Department of Planning and Zoning

TO: Design Advisory Board
FROM: Scott Gustin
DATE: August 12, 2014
RE: 15-0055CA, 15 Conger Avenue

Request: Construct second story addition to existing garage structure and convert to single family dwelling

South ELEV.

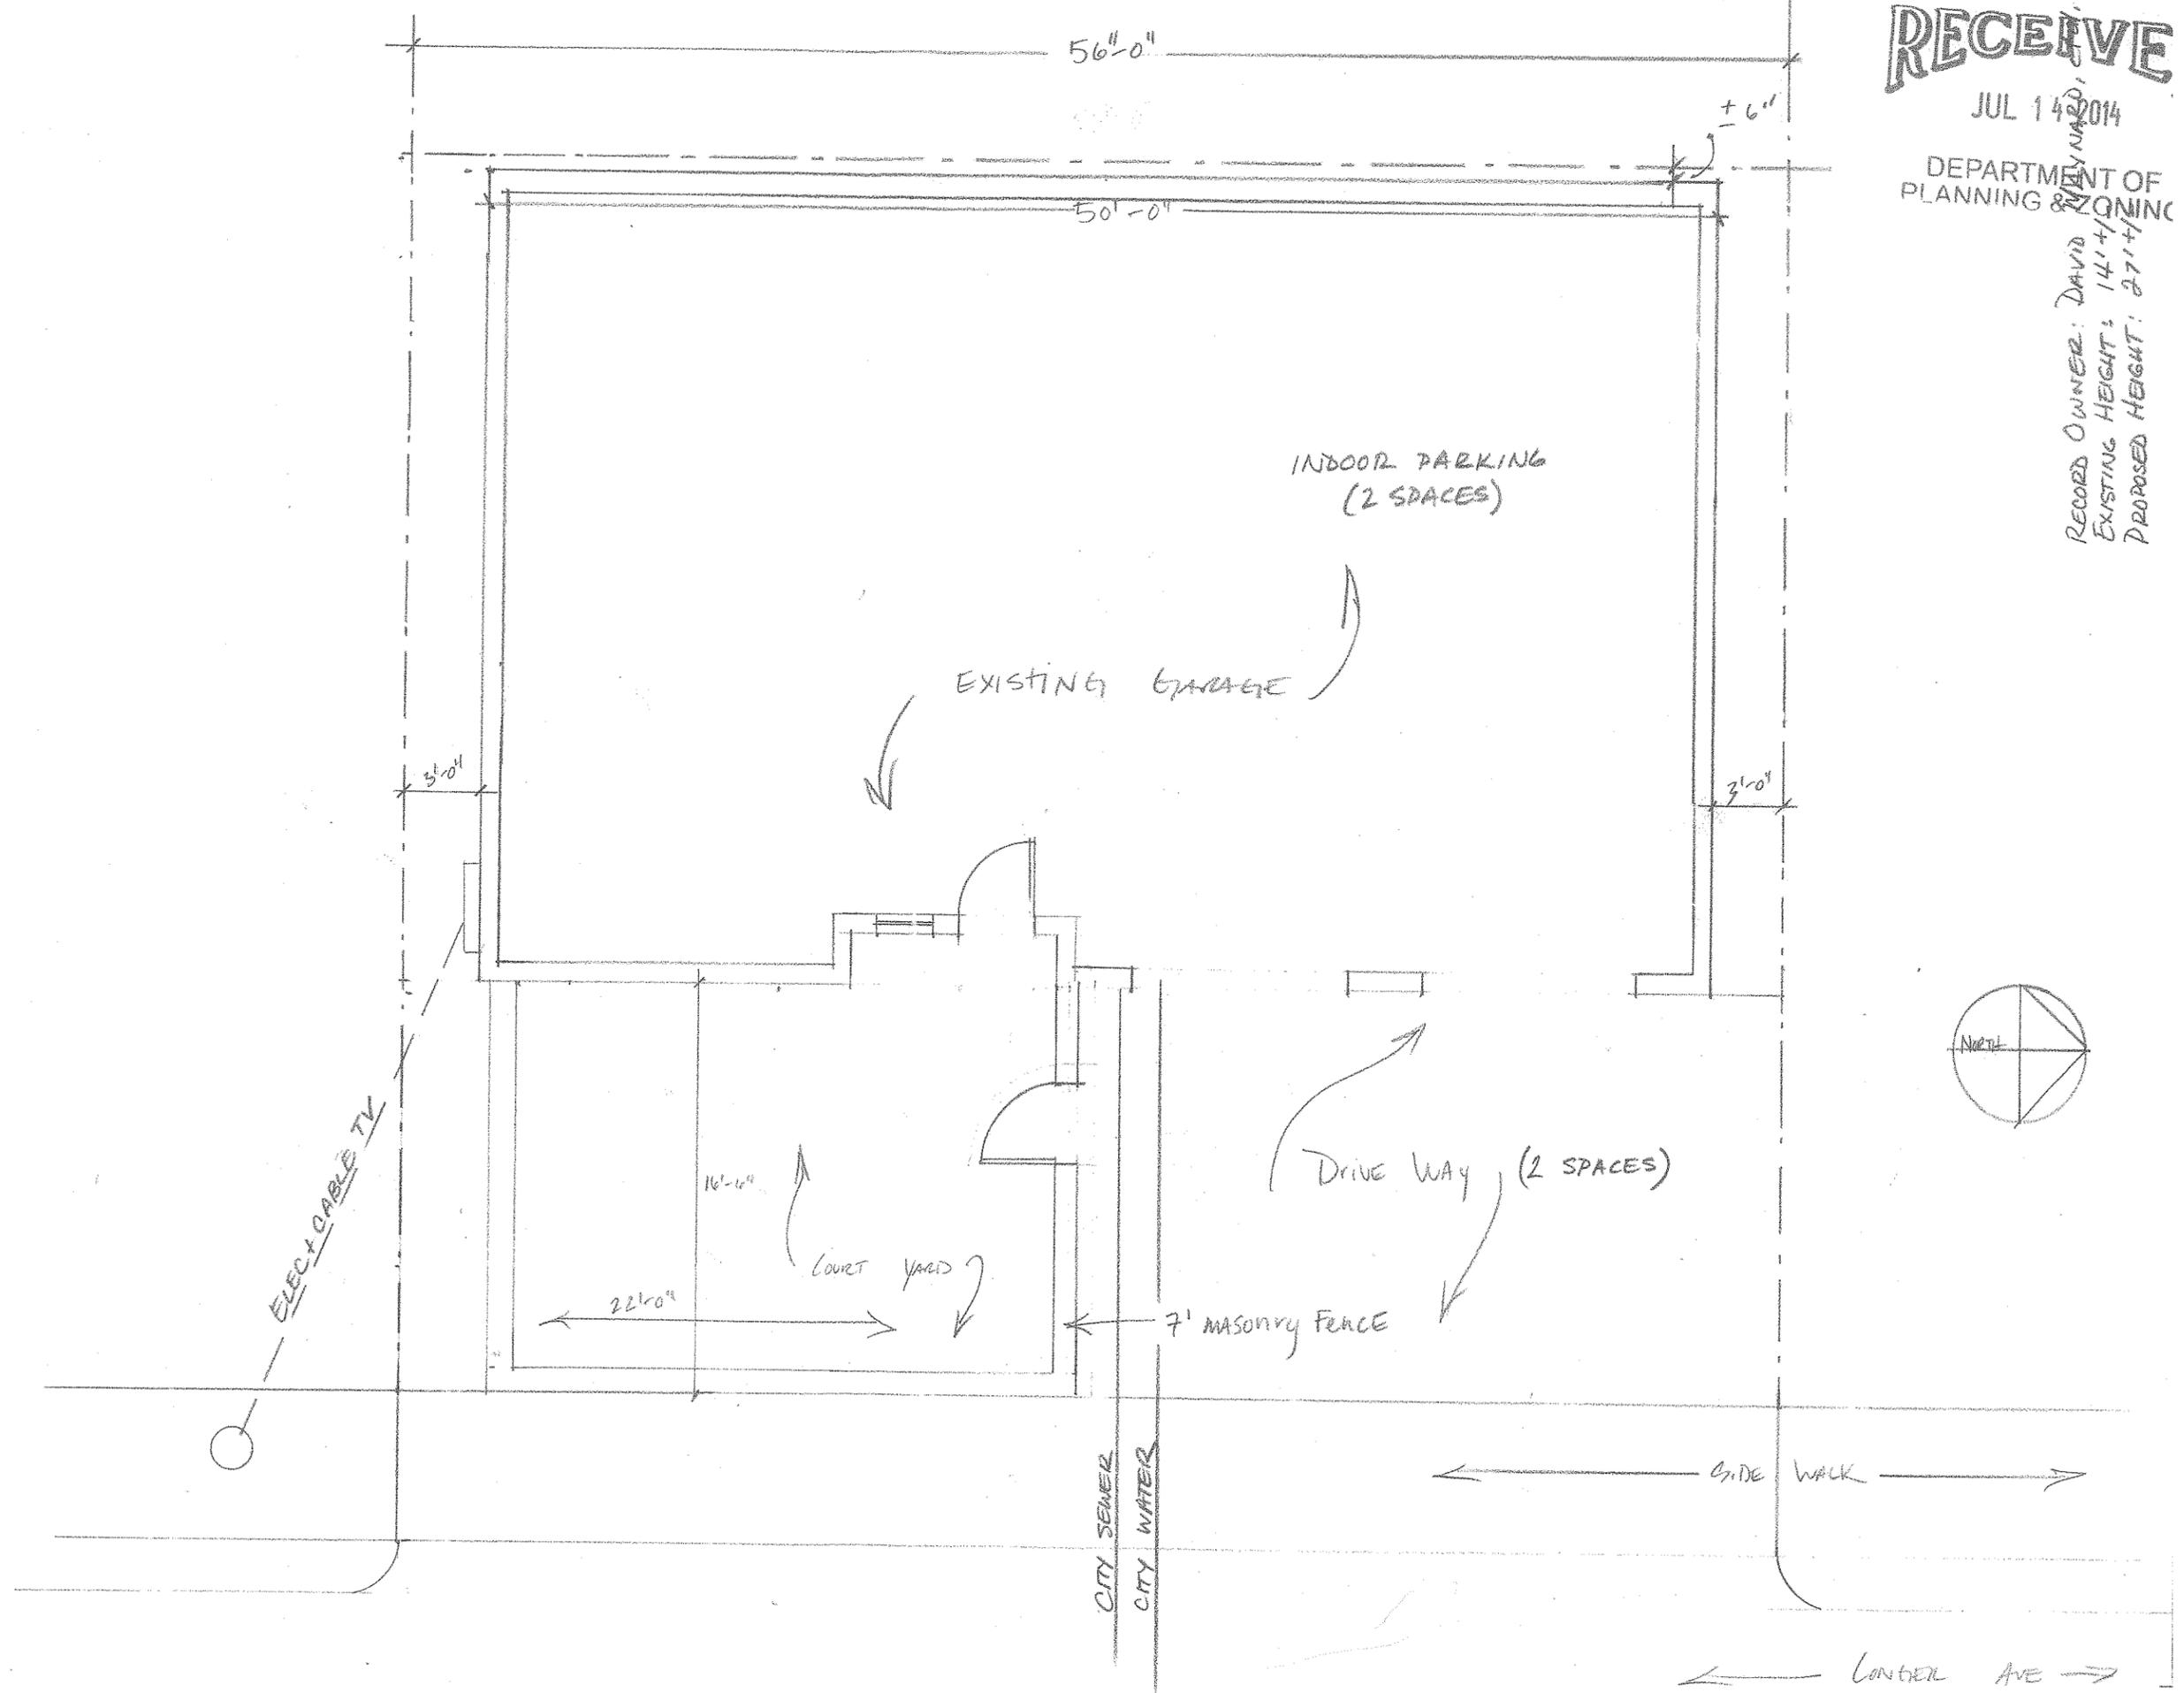
Any new utility lines must be buried. The site plan depicts a utility meter on the south side of the building. The south building elevation does not depict the utility meter. The utility meter must be depicted and screened. See also Sec. 6.3.2 (h) below.

As noted above, utility meters will be located on the side of the building. They must be noted on the building elevation drawing and screened. No exterior mechanical equipment is included in the project plans. If any is proposed, it must be depicted and screened. Trash should be stored inside the garage until curb side pick-up days.
